Southern California Joint Pole Committee

A meeting of the **Routine Revision Committee** took place on the above date, **at 11:11 a.m. via teleconference. Those in attendance were:**

Agenda Item 3 – Item 1597: Review of Routine Handbook Examples (5/19/2015) – Ms. Ortiz opened the discussion on Review of Routine Handbook Examples.

POLE SPACE ALLOCATION
EXAMPLE 14

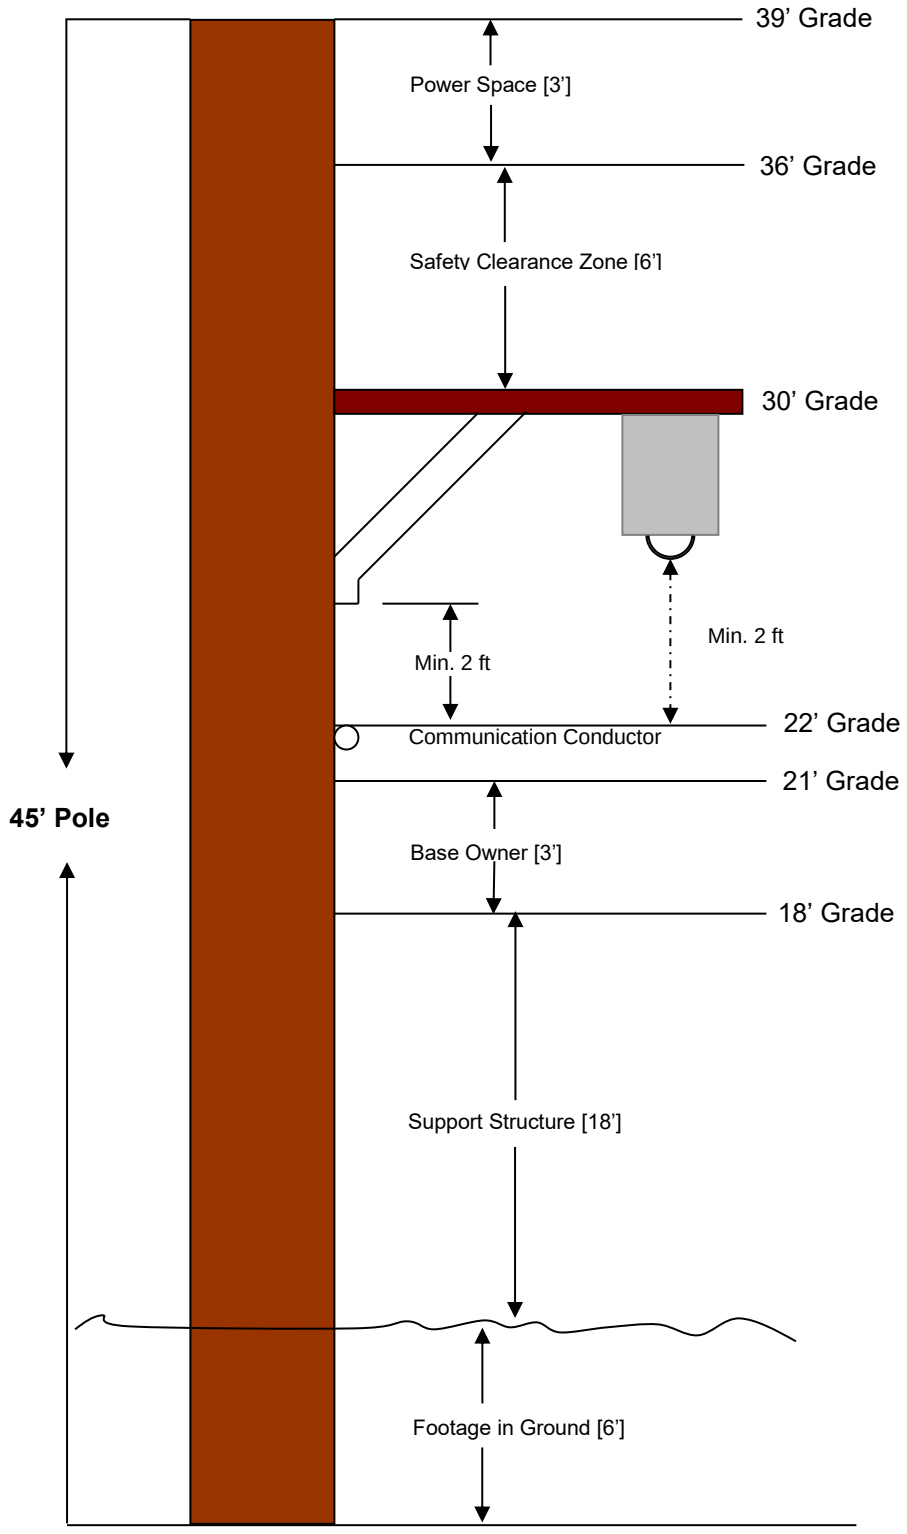
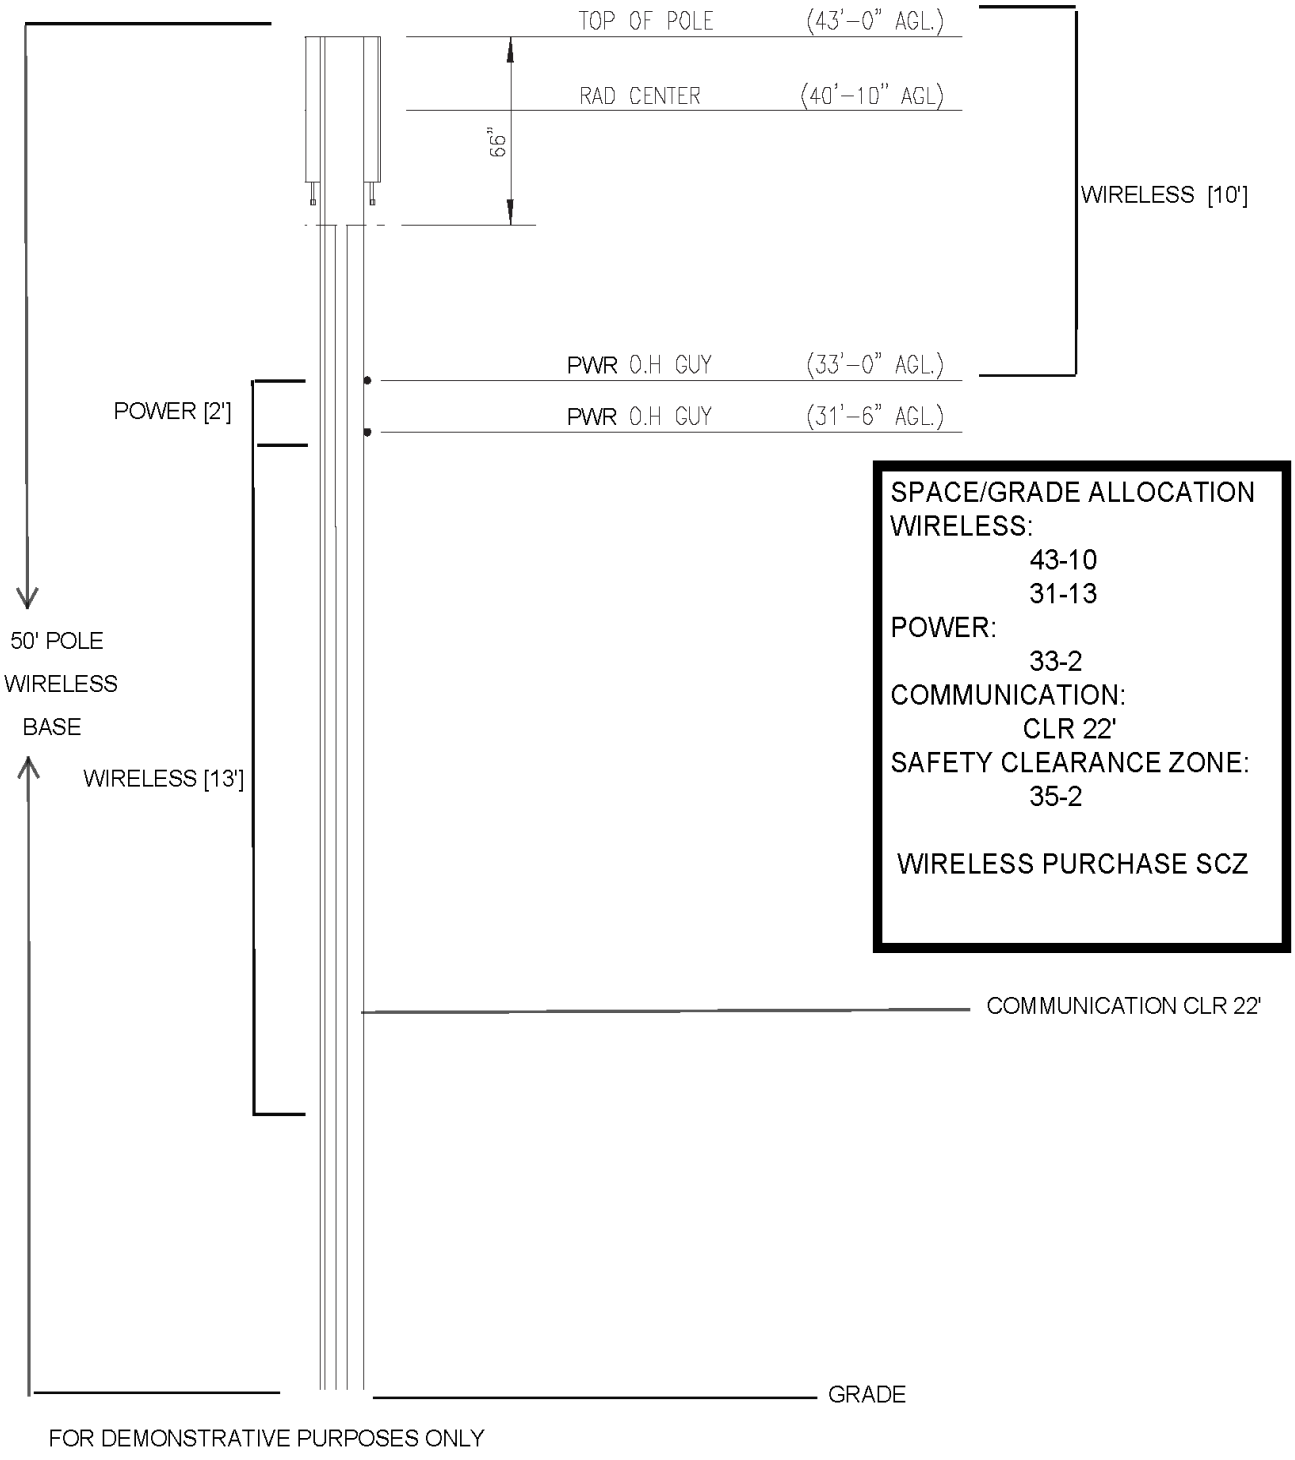
This example shows a 45' with space allocated per the chart in Section 16.1B of this Routine Handbook. For purposes of this example there is one power Member, one communication Member and one wireless Member involved on the pole. Power Member is the base owner.

When section 3.15 is identified, allocation of space shall be configured per example 14 in Section 21 page 21– E14 example. ~~chart 16.1B in Section 16.1.~~ (Revised August 2007).

PRELIMINARY JOINT POLE AUTHORIZATION
CORRECTION OF RECORDS
EXAMPLE 8

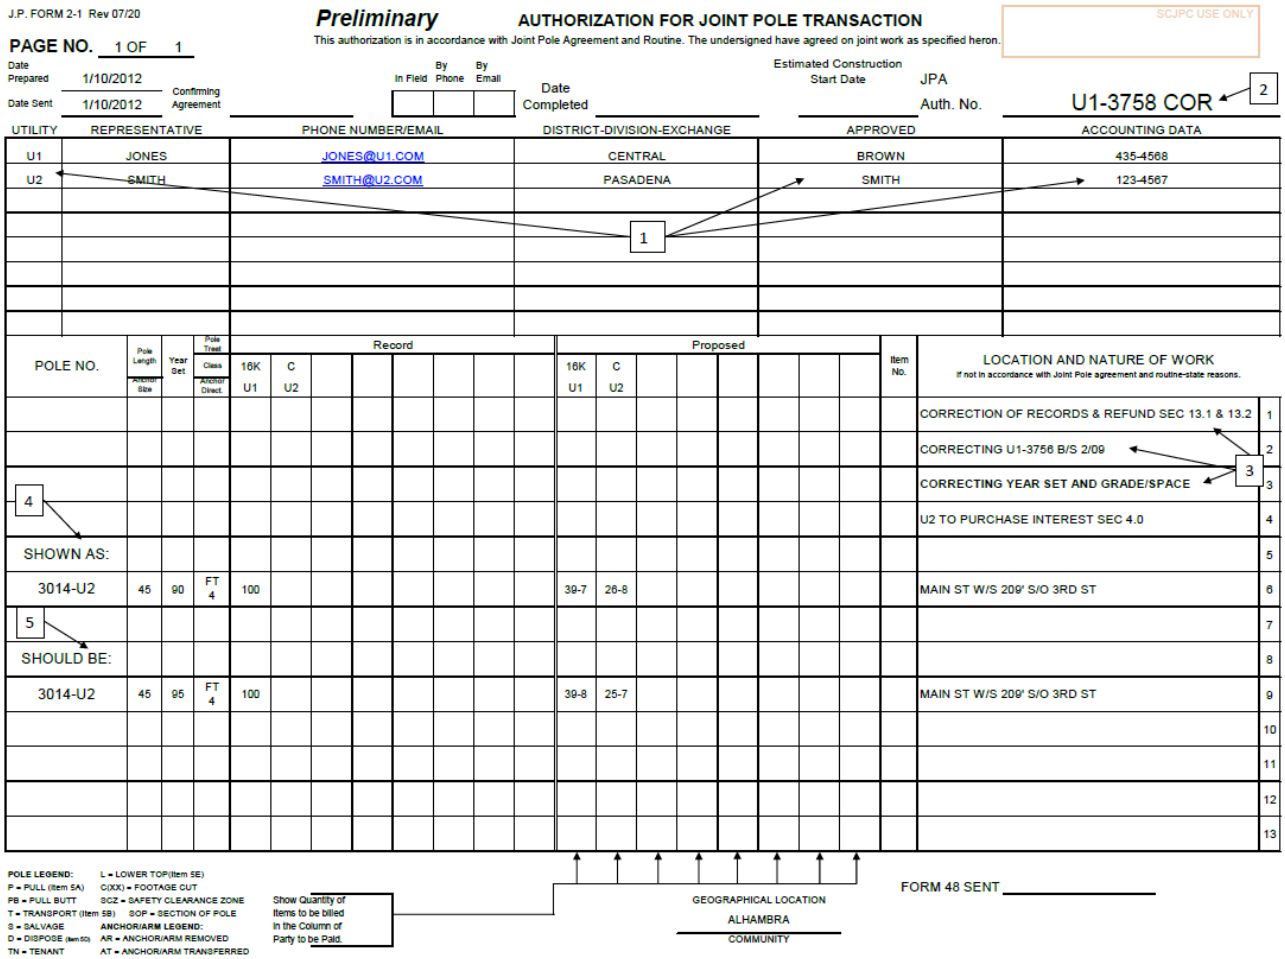
Can we eliminate example 5?

POLE SPACE ALLOCATION
EXAMPLE 14

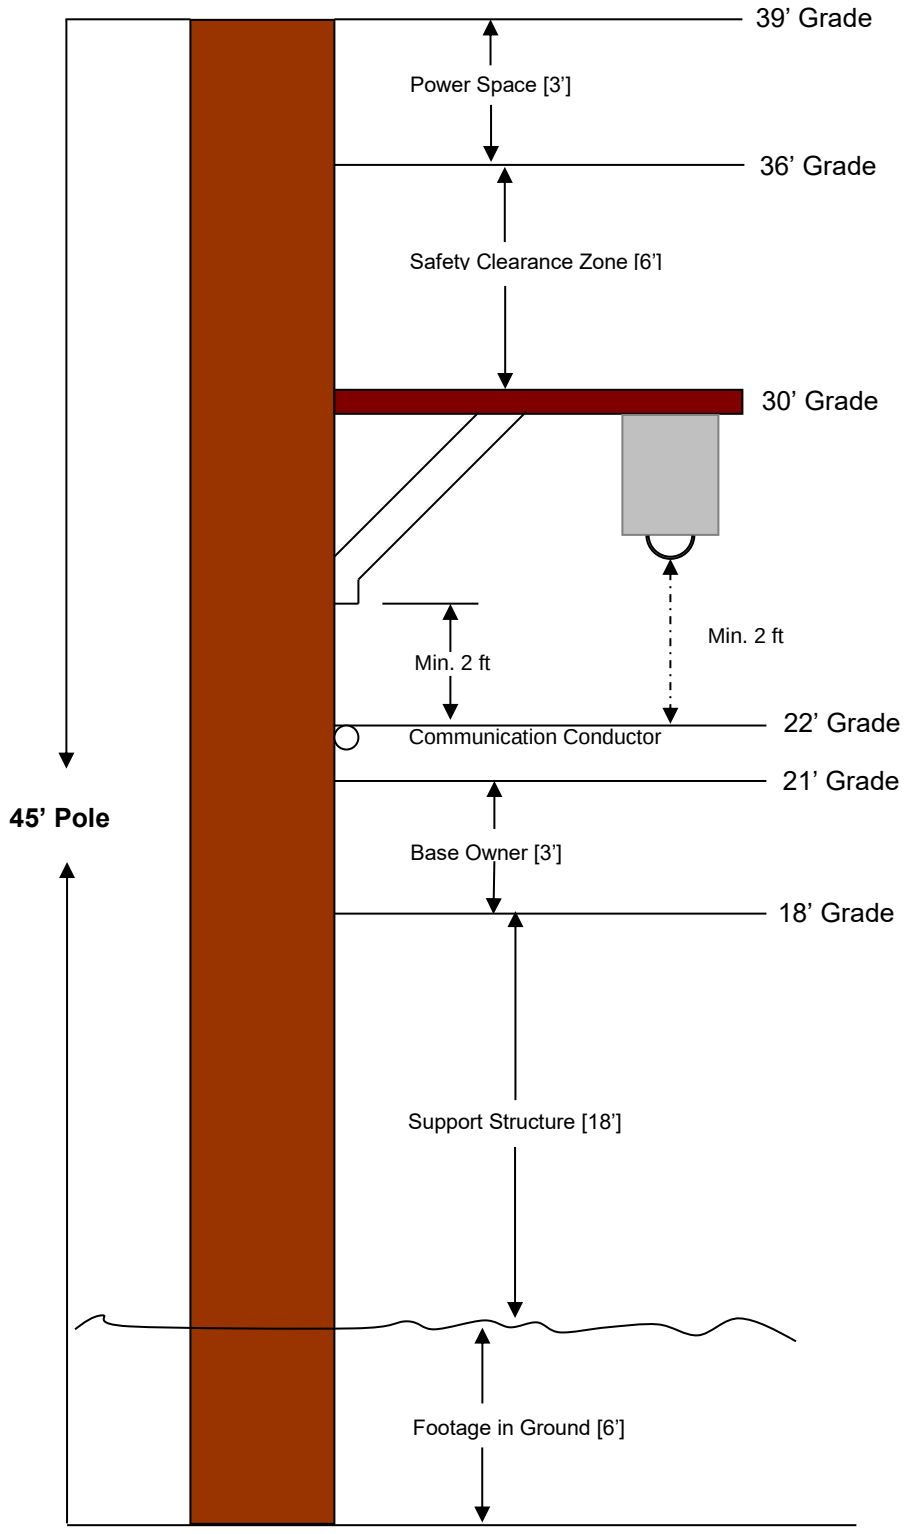
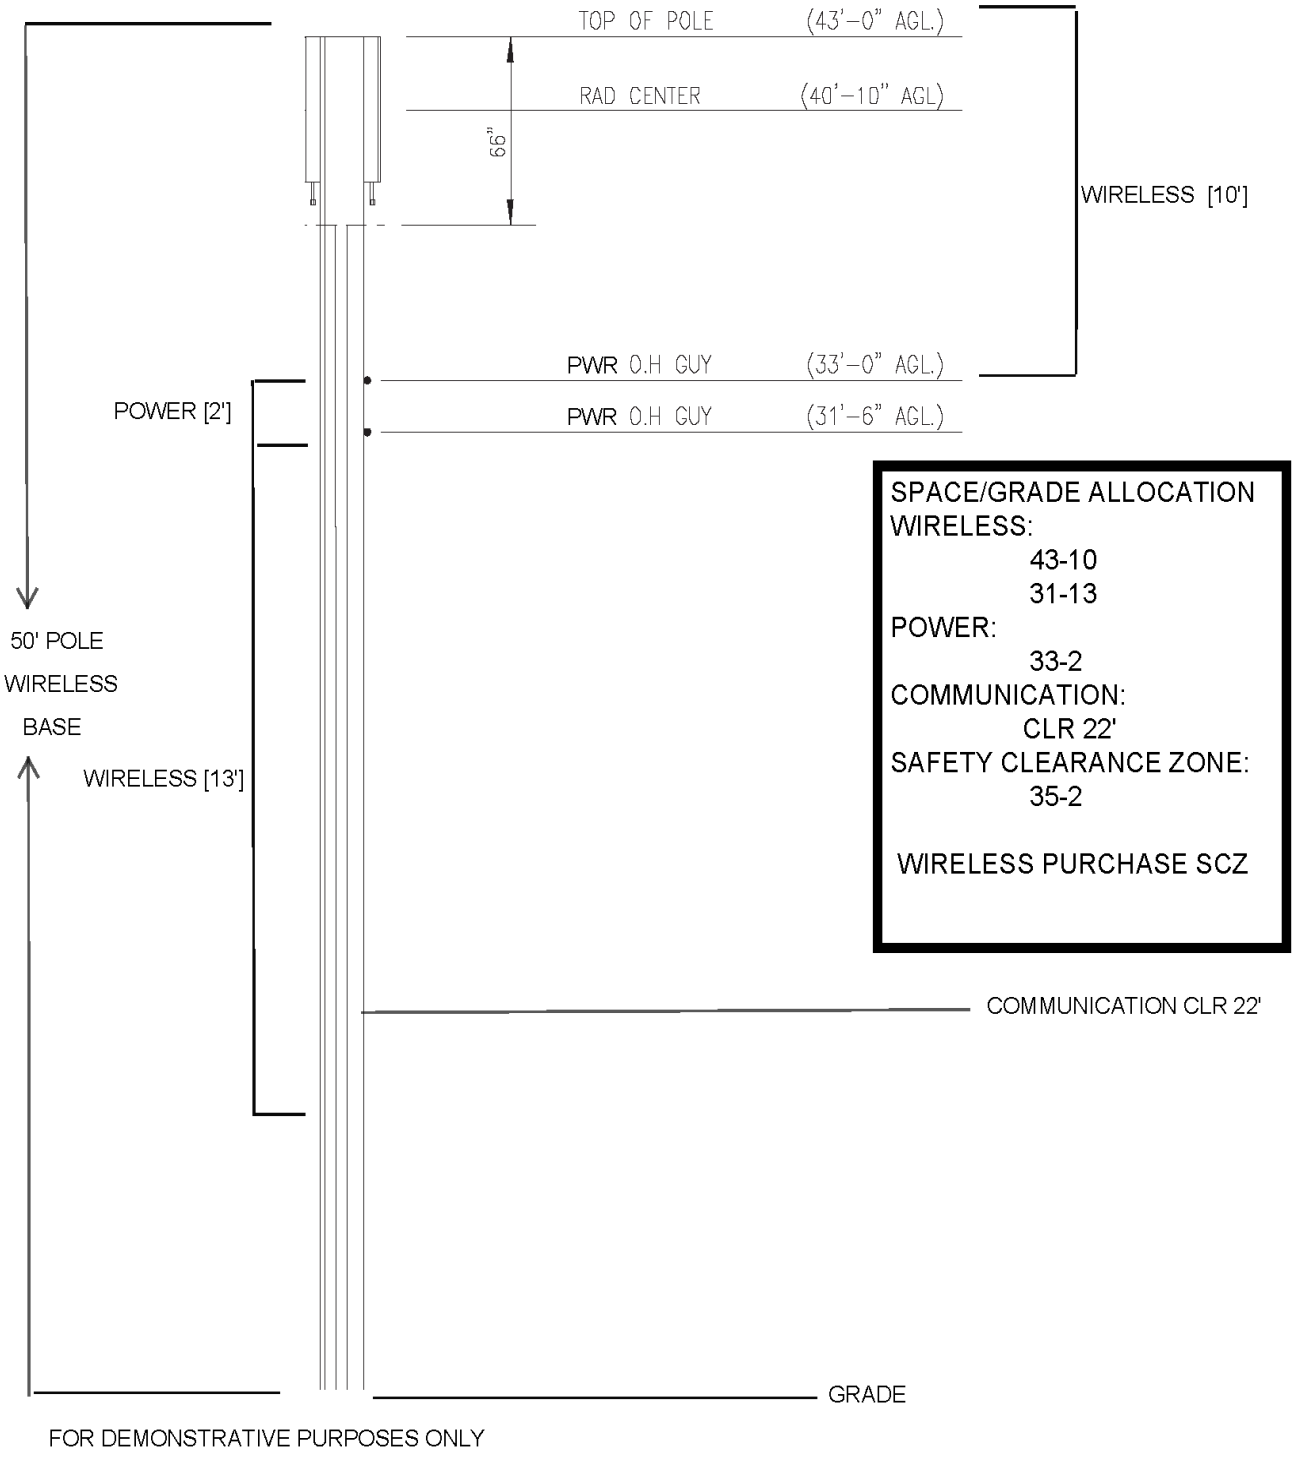
This example shows a 45' with space allocated per the chart in Section 16.1B of this Routine Handbook. For purposes of this example there is one power Member, one communication Member and one wireless Member involved on the pole. Power Member is the base owner.

PRELIMINARY JOINT POLE AUTHORIZATION
CORRECTION OF RECORDS
EXAMPLE 8

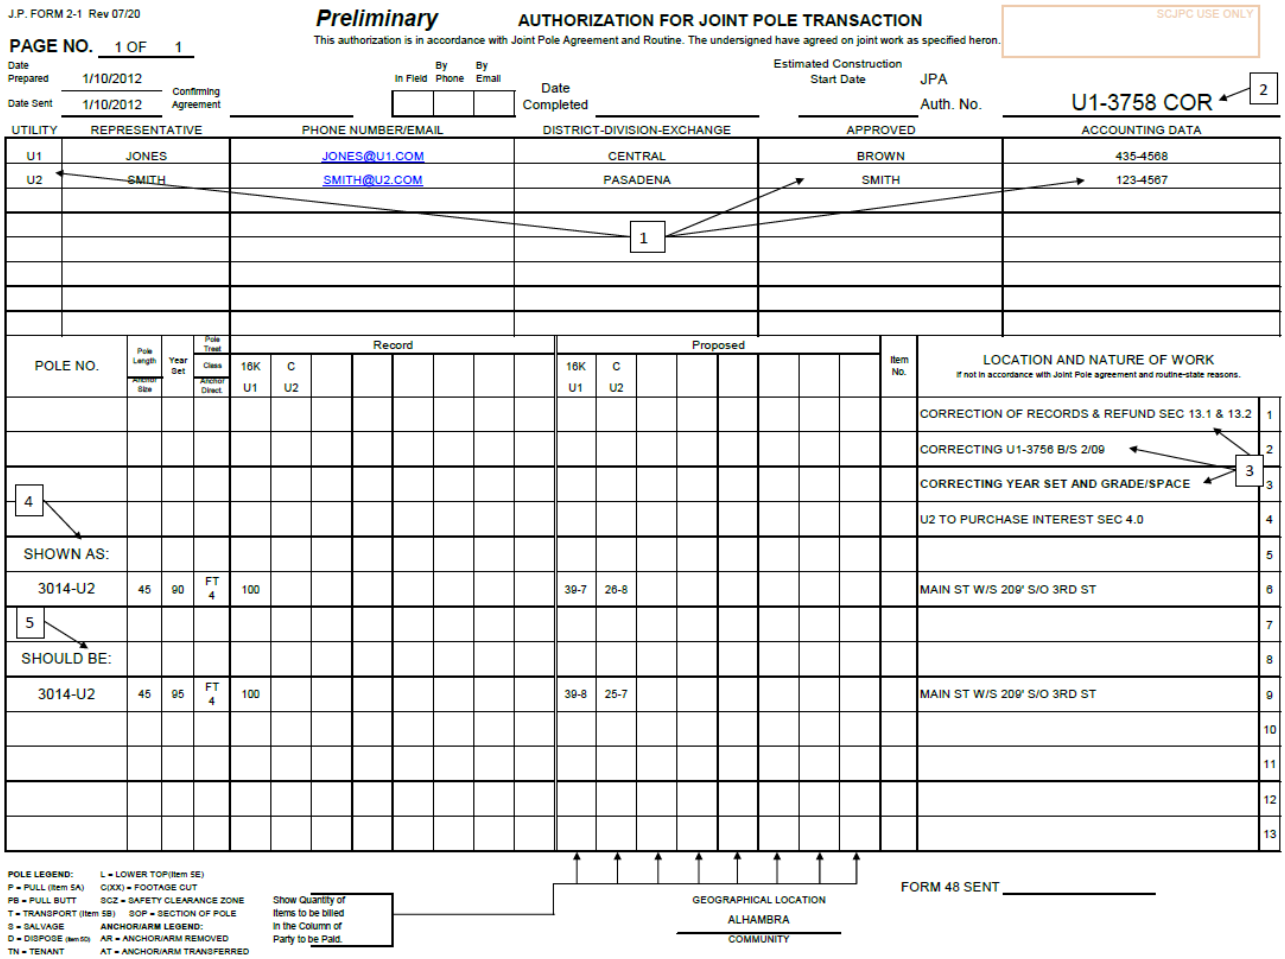
Can we eliminate example 5?
